Charged Kaons at the Main Injector

June 4, 2001

Answers to PAC & Technical Review Committee Questions

Figure 1: The angle between decay and scatt. planes

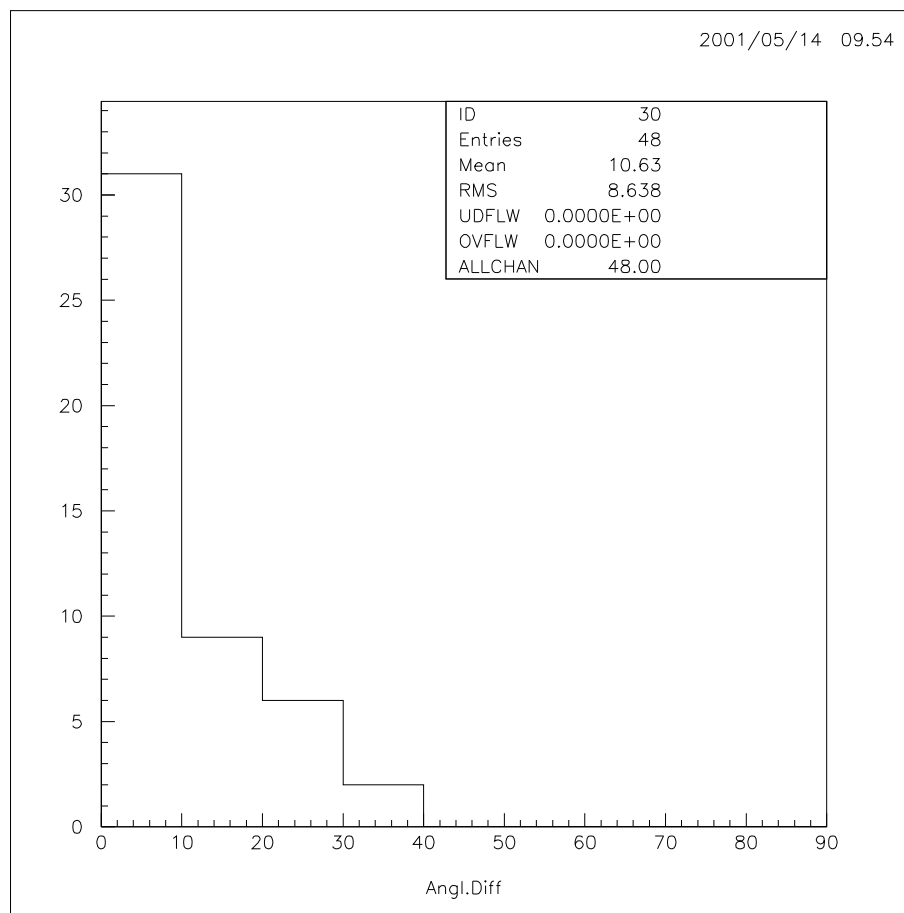
Q5. Provide the missing mass spectrum of the background divided into relevant categories such as event topologies.

The mis-measurement of missing mass in these events is too big to come from resolution tails. So the above 52 events were reproduced in our GEANT Monte Carlo and studied with the assumption that either the kaon or the pion track had been deflected after (for K) or before (for π^+) it was measured. We printed out each step where GEANT deflected a track at an angle above a threshold of .75 mRad.

Indeed, 48 of the 52 events had such a large scattering step. We are currently studying the other 4 events to determine their background mechanism. The detailed results are presented in Table 3. Here is a brief summary:

Of course such a scattering event should not have passed our analysis cut on DOCA (distance of closest approach between the kaon and pion tracks) unless the scattering plane is close to the same as the decay plane. To check this we histogrammed the angle between these two planes (see Figure 1, where the scale is in degrees). This data shows that the scatter plane and decay plane are definitely correlated.

Figure 3: The fractional deviation [%] in the field integral of the KTeV spectrometer magnet across the face of the magnet aperture. The circle shows the aperture of the CKM VVS. The total deviation inside this circle is $\pm 0.2\%$

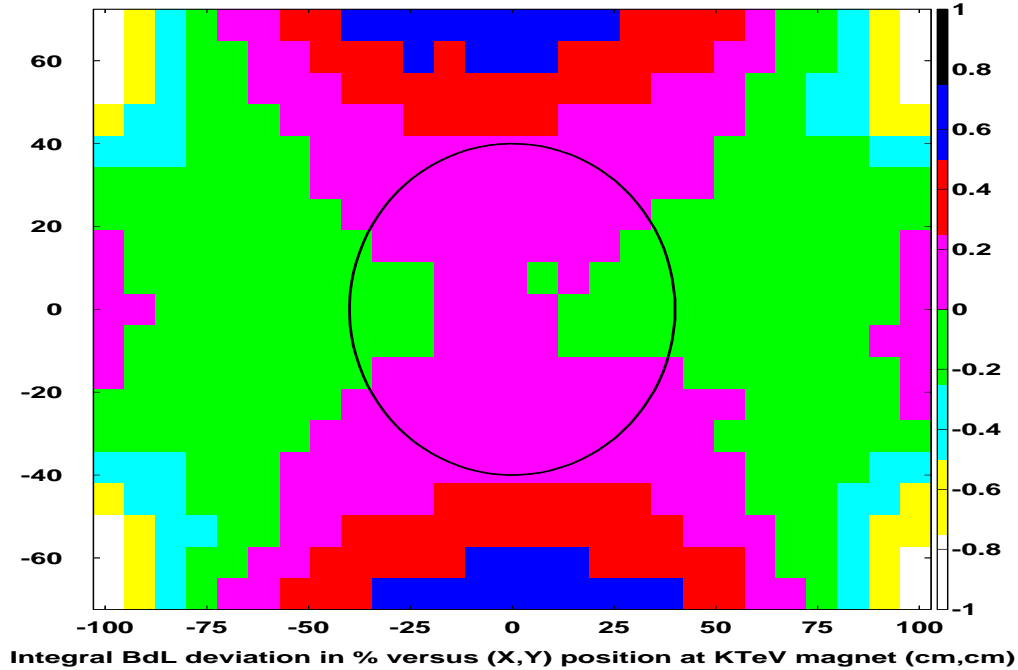
Q4. *A potential mechanism for correlation of the velocity and magnetic missing-mass measurements is the variation of the field integral across the DMS spectrometer magnetic. The pion RICH measured momentum vector must be propagated back through the DMS magnet to recover the pion's decay angles. The RICH cannot measure position so only an average field*

integral is available without appealing to the straw-tube spectrometer for the track's position. Is this a problem?

We reproduce in Figure 3 the measured field integral as a function of transverse position across the face of the KTeV spectrometer magnet. This magnet is the model we have been using for the still undesigned CKM spectrometer magnet. The superimposed circle is the 40cm radius aperture of the VVS. The total variation in field integral across this aperture is $\pm 0.2\%$. The momentum resolution of the pion RICH is about 1%. The variation in field integral will make a negligible contribution to the overall pion RICH momentum resolution.
